3.1a Lot 32 (1324) Thomas Road, Oakford - Proposed Oat Mill Operating Facility and Associated Buildings and Structures - 'Industry-Rural' – DAP/25/02840

**Part C – Item 3.1a – LOT 32 (1324) THOMAS ROAD, OAKFORD –  
PROPOSED OAT MILL OPERATING FACILITY AND ASSOCIATED  
BUILDINGS AND STRUCTURES - ‘INDUSTRY-RURAL’**

**Form 1 – Responsible Authority Report  
(Regulation 12)**

**Figure 5 - Planning Control Area**

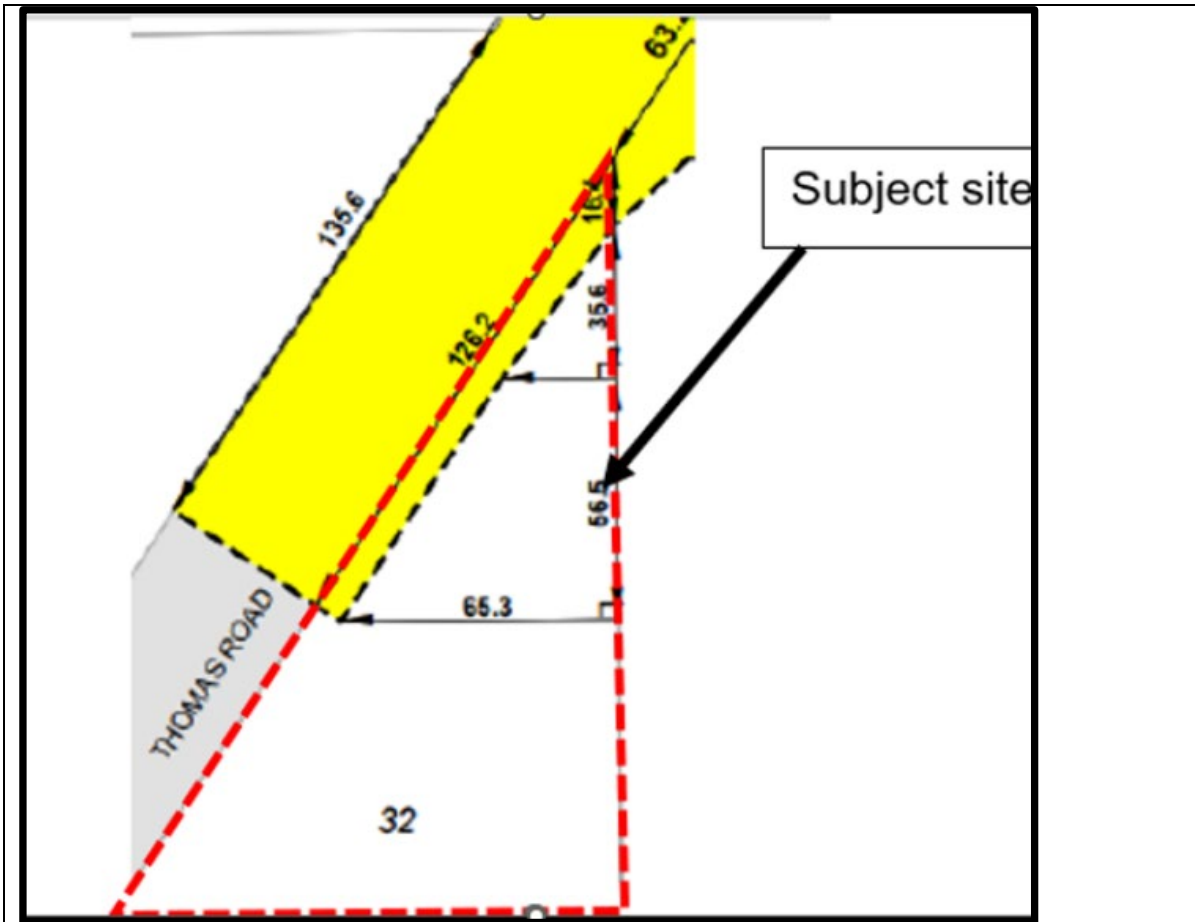
<p><b>Department of Planning Lands and Heritage (DPLH)</b></p>
<p><b>Government Agency Response:</b> <u>WAPC Planning Control Area No. 171</u> The northern portion of the is identified within the planning control area which relates to proposed longer term road upgrading works associated with the intersection of Thomas and Anketell Road.</p>

**Officer Comment:**

**Figure 6- Location of sensitive Receptors**

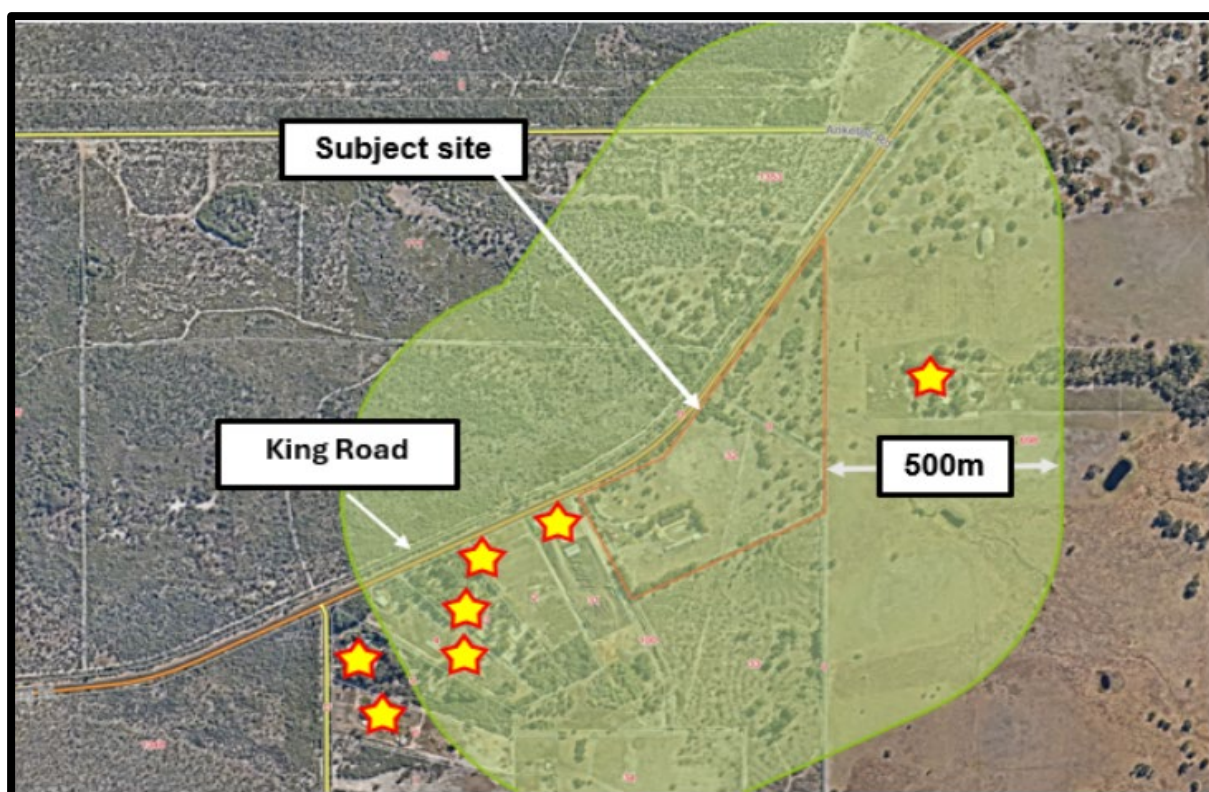
The separation distance recommended between a 'Grain Cleaning' premises and sensitive land uses is between 300 - 500m depending on size of the operation. Potential off-site impacts are listed in the Guidance Statement as noise, dust, and odour. For worst case scenario, the separation distance of 500m has been used as shown following:

There are five sensitive receptors within the separation distance. Where sensitive receptors are located within the generic separation distance (500m), technical reports are required to demonstrate how specific impacts as referenced in the Guidance Statement are proposed to be managed. This is discussed following:

**Figure 7 - Full Movement Driveway**

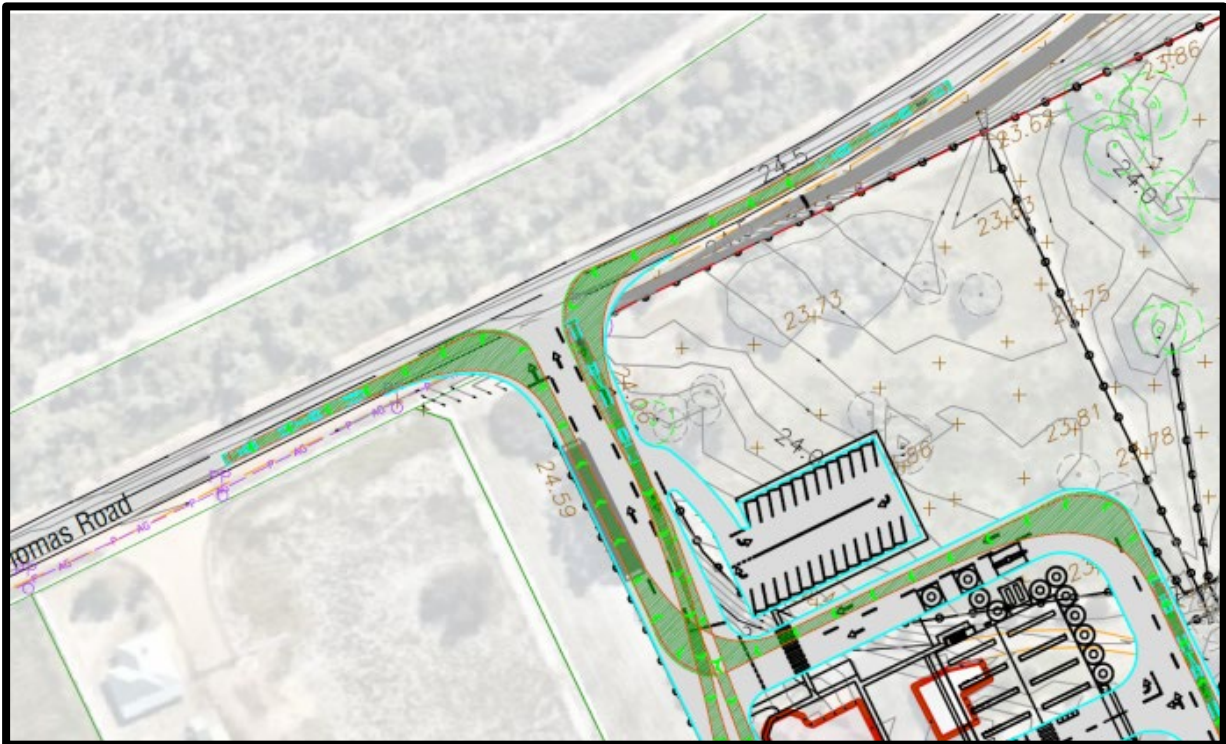
As the site abuts Thomas Road which is designated as a Primary Regional Road (PRR) it is required to be referred to MRWA for comment. MRWA initially reviewed the design and requested that the driveway and access be Left-in, Left Out (LILO) configuration in order to minimise conflicts between turning vehicles and oncoming traffic.

However, under Clause 28 of the Metropolitan Region Scheme (MRS) Text, the exercise of decision-making powers by the local authority (in this case, the Shire or MODAP) is only permitted where the advice or recommendation provided by the public authority - MRWA - is supported. In this instance the non-support of the application from MRWA and the Shire's supportive RAR, the application, along with MRWA's advice or recommendations, must be referred to the Department of Planning, Lands and Heritage (DPLH). Accordingly, the application has been referred to DPLH to prepare a Responsible Authority Report (RAR) for consideration by the MODAP that will deal with the access arrangements proposed.

**Figure 12 - Proposed Turn around and Fire Fighting Equipment**

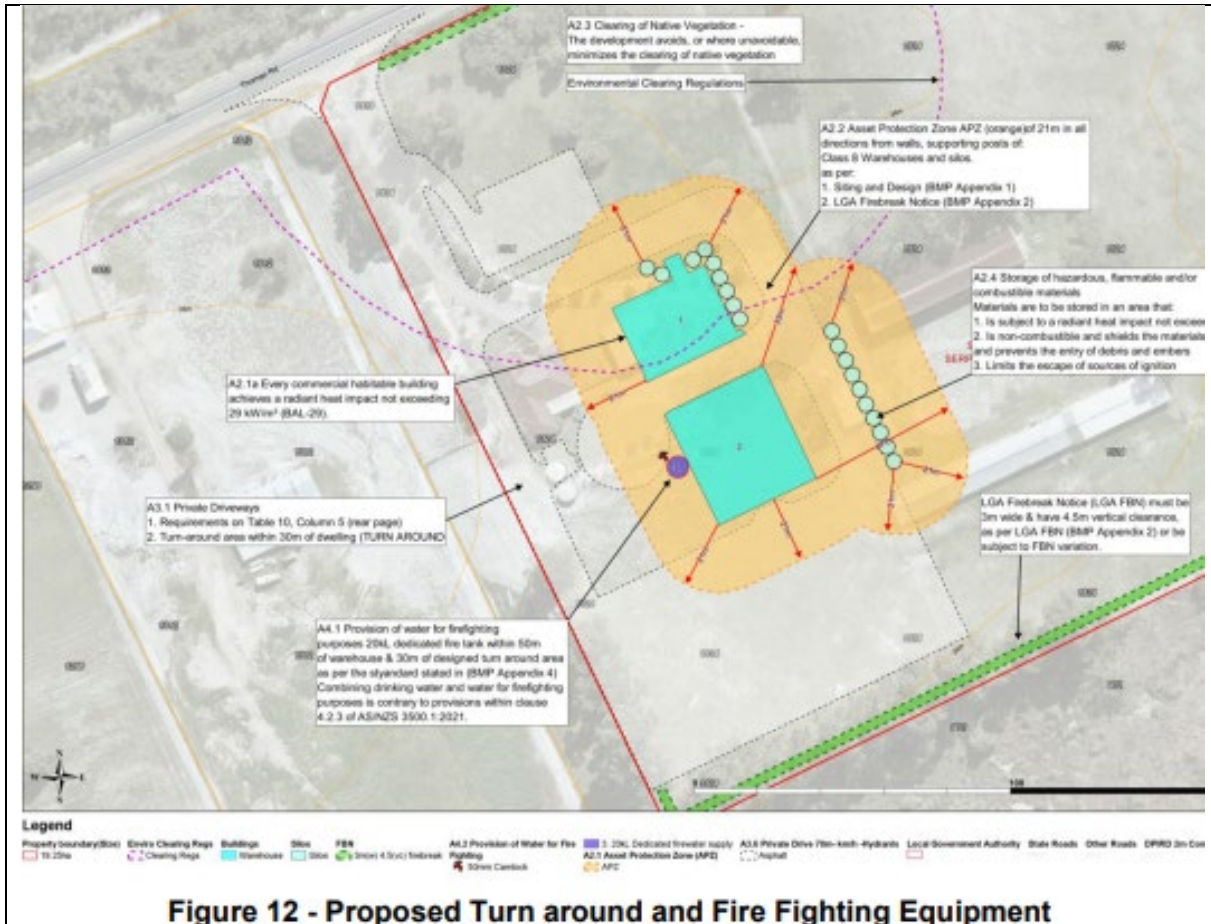
<b>Bushfire Protection Criteria</b>	<b>Provided</b>	<b>Compliant</b>
Element 1: Location	Not applicable	NA
Element 2: Siting and design of development - Asset Protection Zone (APZ)	The proposed development area has been provided with a APZ area which will ensure all development surrounding the development will be maintained to a low fuel standard. Any other classified vegetation site will therefore will only provide a radiant heat factor of BAL-29 which is an acceptable requirement to the guidelines.	Yes
Element 3: Vehicular access	The subject site is accessed via existing public roads, with access/egress point into subject site coming off Thomas Road All of the surrounding roads are bitumen with estimated width of the sealed surface achieving a minimum width of $\geq 6\text{m}$ and therefore the existing road network would provide suitable access and egress for the community and emergency services personnel in the event of a bushfire. The site provides adequate turn around areas in accordance with the guidelines.	Yes

Element 4: Water	The applicant has proposed 1 x 20kl dedicated firefighting water tank. The requirement is currently 10kl and thus the proposal exceeds the requirement under the guidelines.	Yes

**Figure 13 – Built Form**

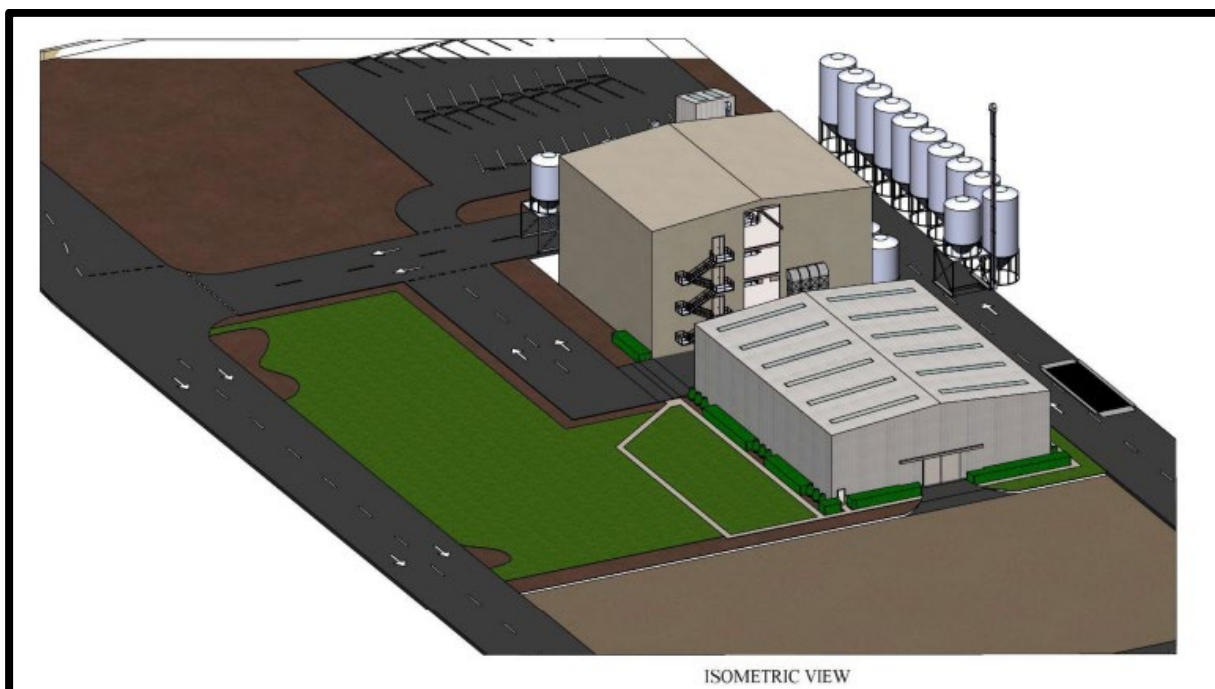
As discussed above the proposed silos, and processing and storage sheds are located approximately 100metres from the street. As seen from figure 11 above, the majority of the silos are located behind the main grain holding shed and therefore would not be adversely visible from Thomas Road and are located reasonable enough for the adjoining neighbouring property. The visual impact of the silos fronting Thomas Road would be ameliorated by the separation distance of 100m and existing trees along this section of the freight route.

However, to further satisfy the concerns raised during the consultation period and improve the visual amenity and rural character of the area, the requirement for a Landscape and Vegetation Plan has been recommended as a condition of approval. The Landscape and Vegetation Plan must show areas of retained vegetation and proposed additional planting and the number of each species to be planted on site. Within the addition of this requirement, it is considered that the proposed built form would not unduly impact on amenity subject to further landscaping.
